June 13, 2025

City of Aurora
Planning Division

RE: Debreselam Medhanealem (Savior Of The World) Church - Site Plan
Application Number: DA-2386-00, Case Number: 2024-6033-00
3rd Review Applicant Response Letter

02 North Architectural Building Elevation
1/8" = 1'-0"

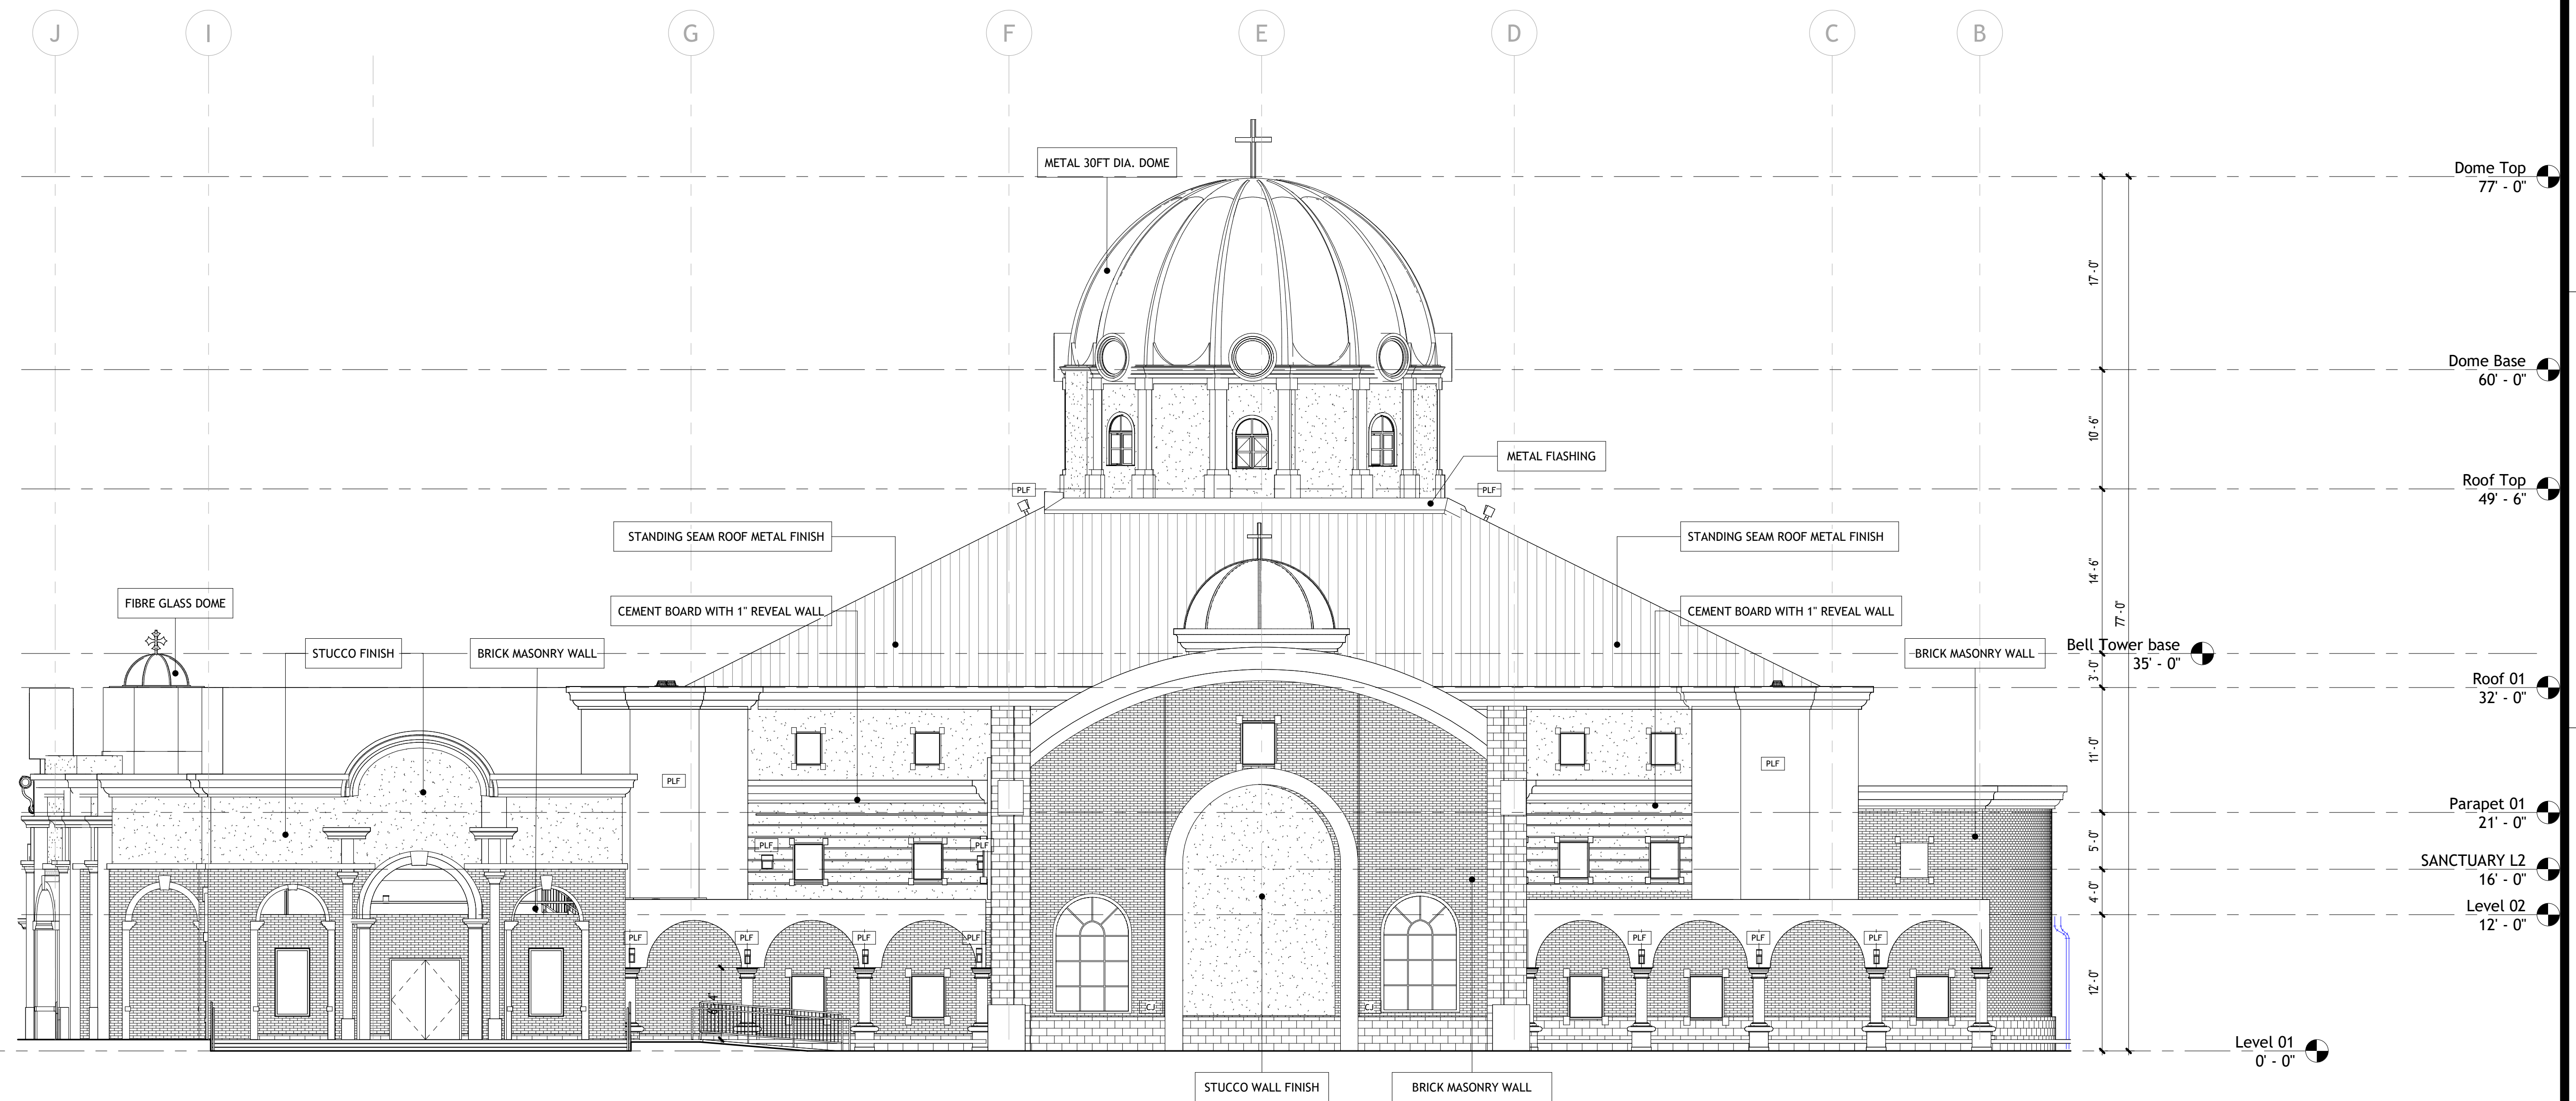
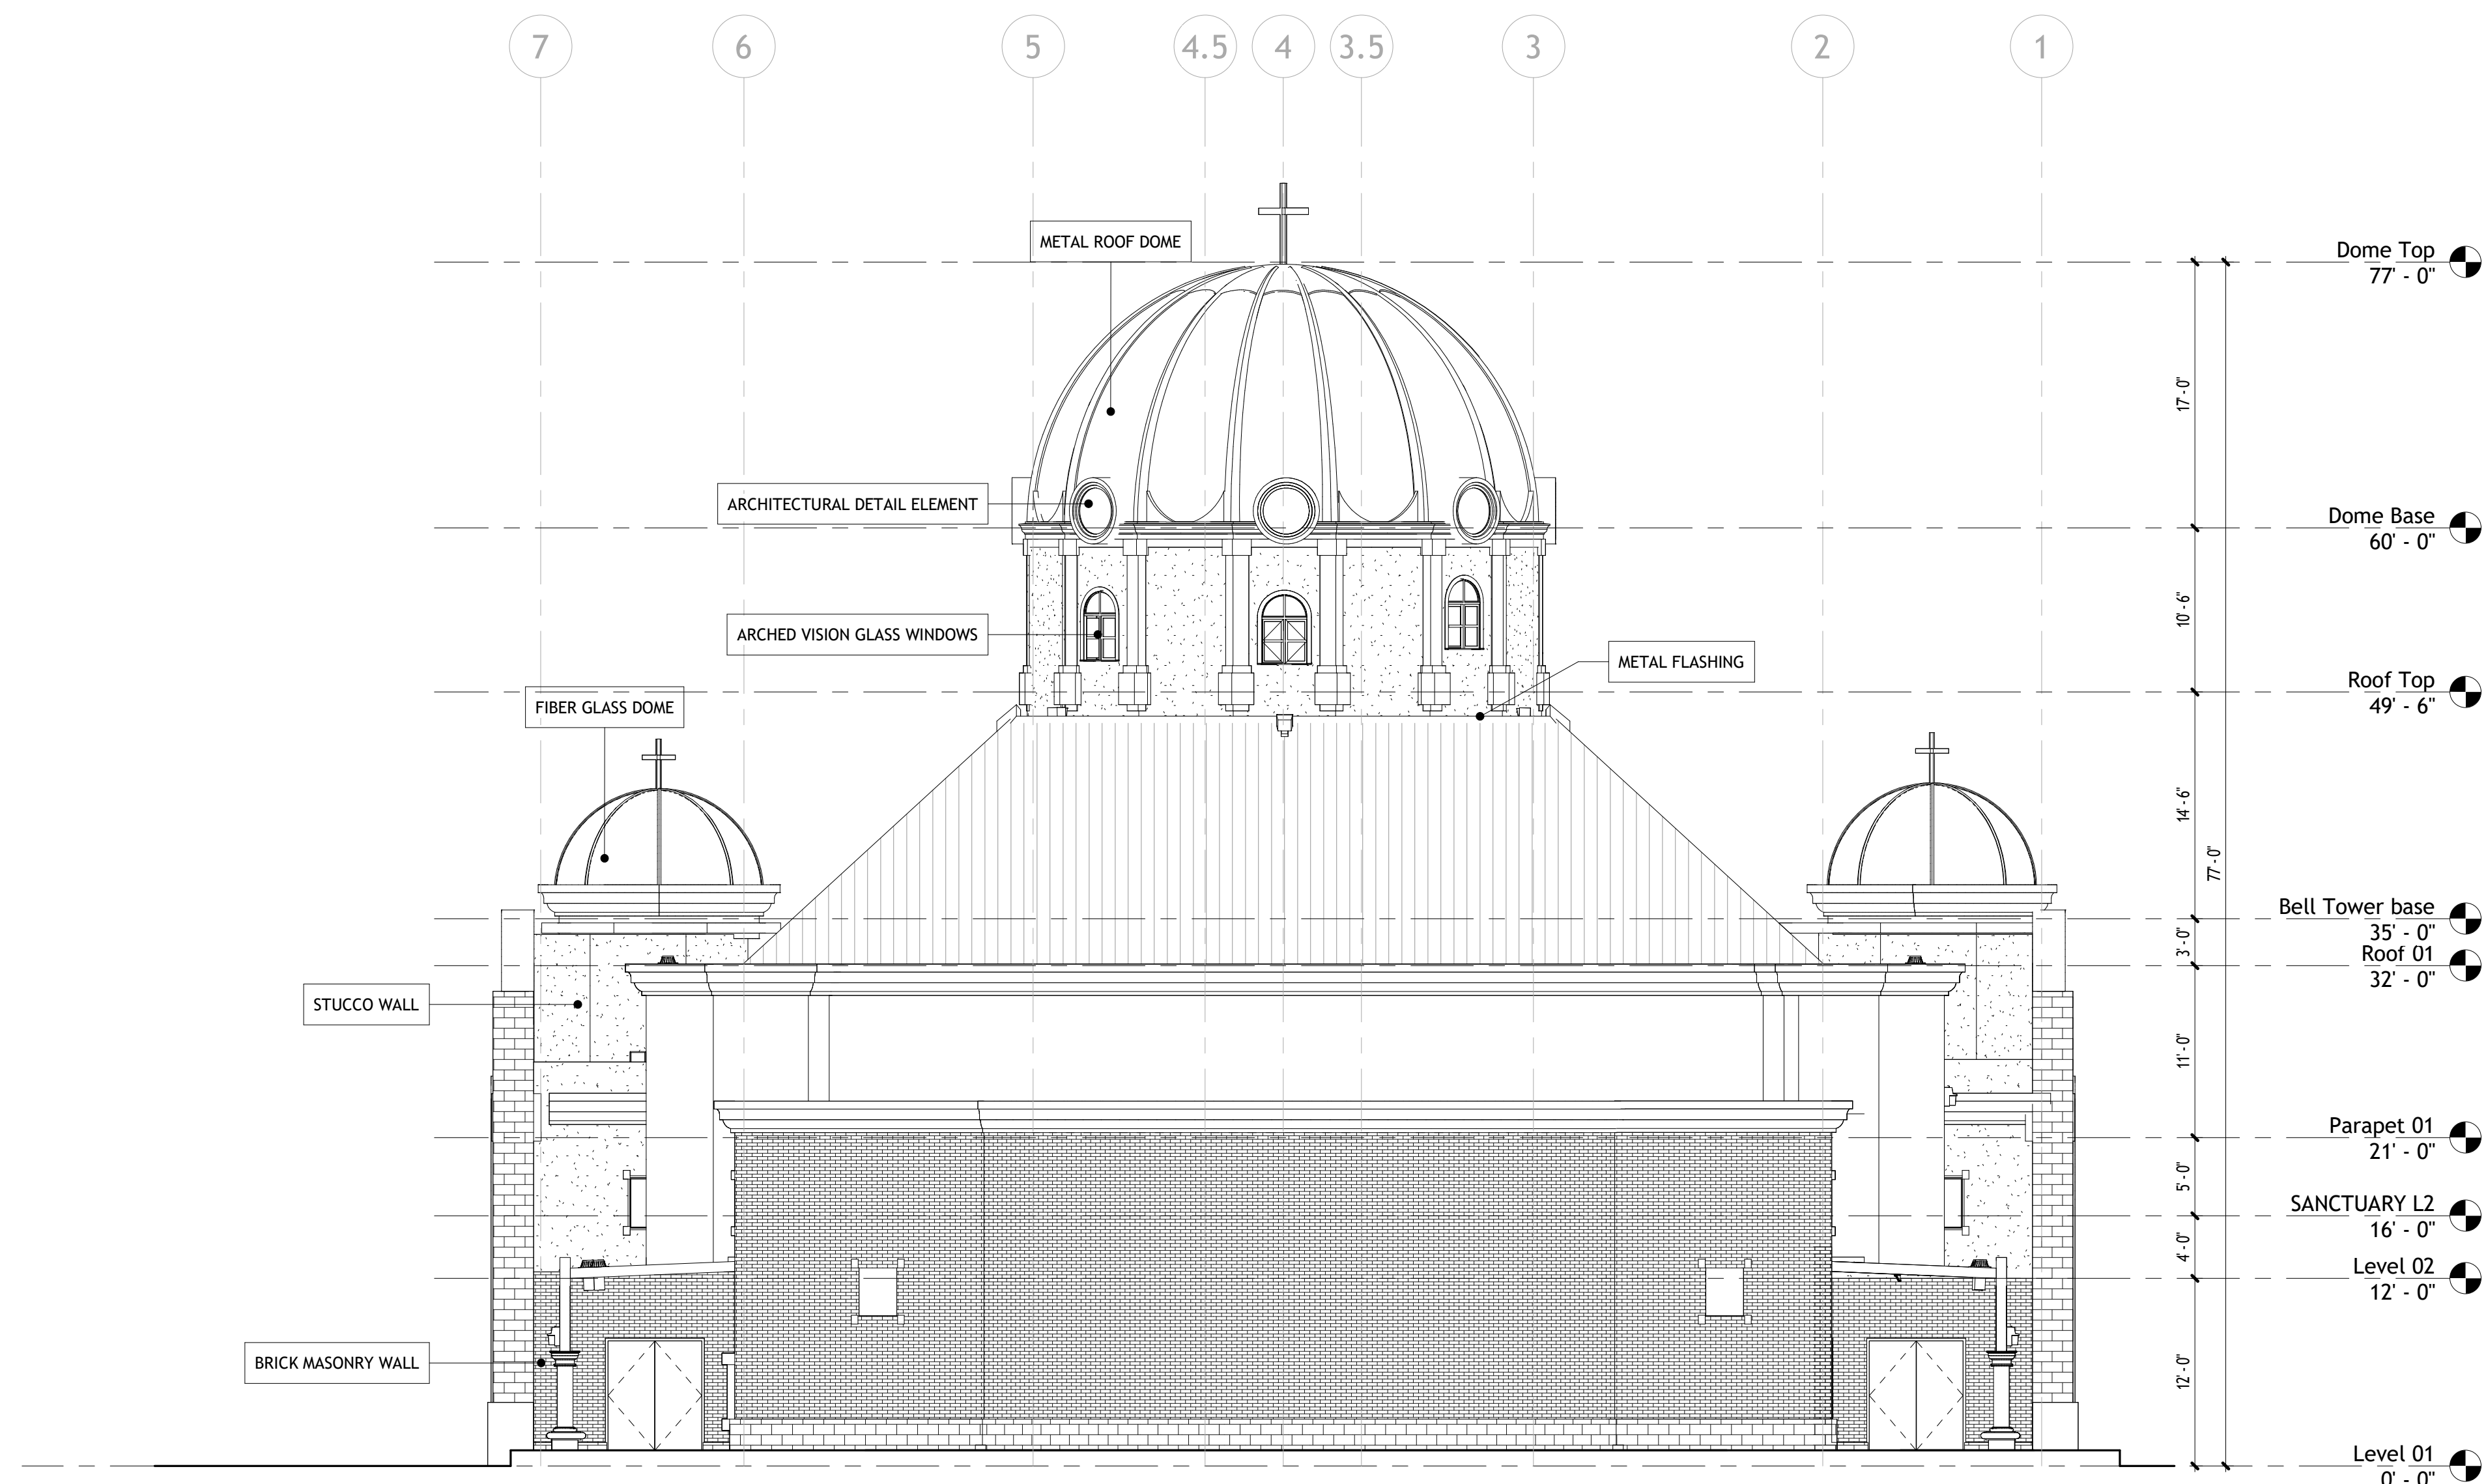
Add these signs to
elevations. TYP

Third request.
For each
building, where
applicable, show
the following
features: FDC,
fire riser room
door, Knox box.
TYP

Remove copyright notes
restricting reproduction of
the approved plans and
reports. (3.D.7 of the 2025
COA Roadway Manual)
(TYP)

Identify Sanctuary as
Building A from site
plan. TYP

Signs have been added and
labeled.

Copyright notes
have been
removed.

NORTH ELEVATION

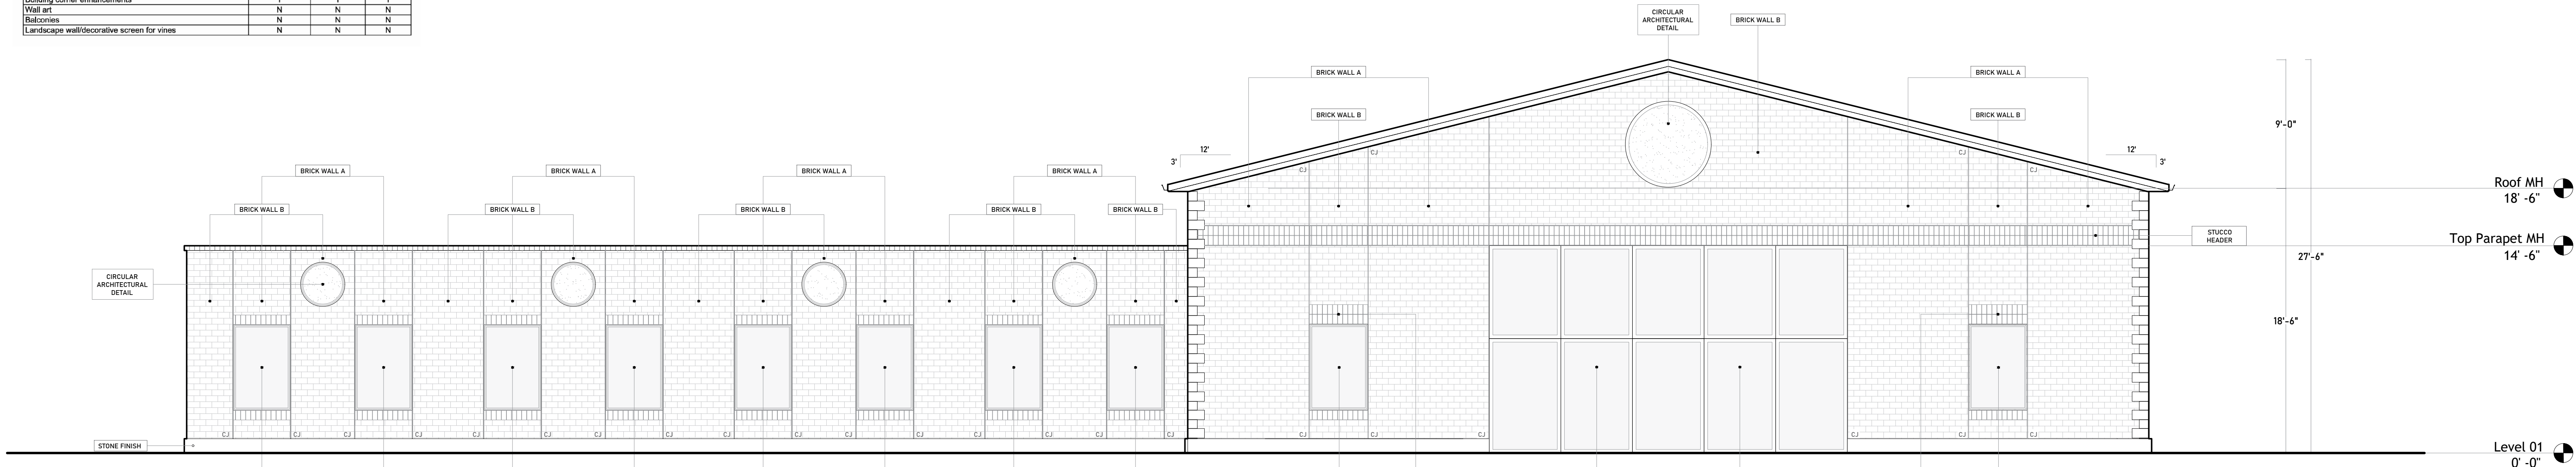
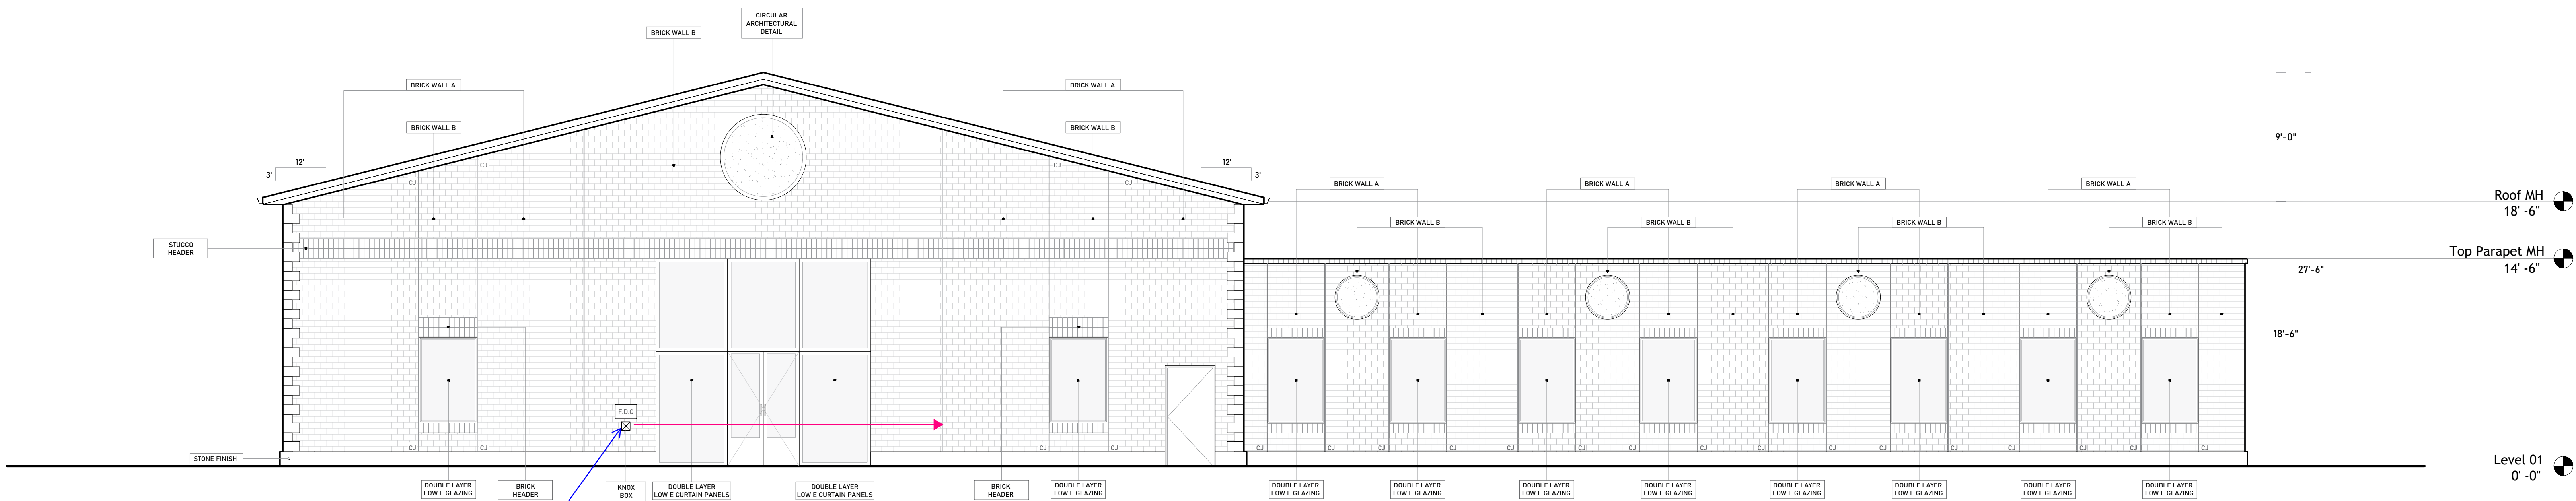
FDC and Knox location is different from site plan.

Identify Main Hall as Building C from site plan. TYP

FDC and Knox box locations have been updated to match the site plans
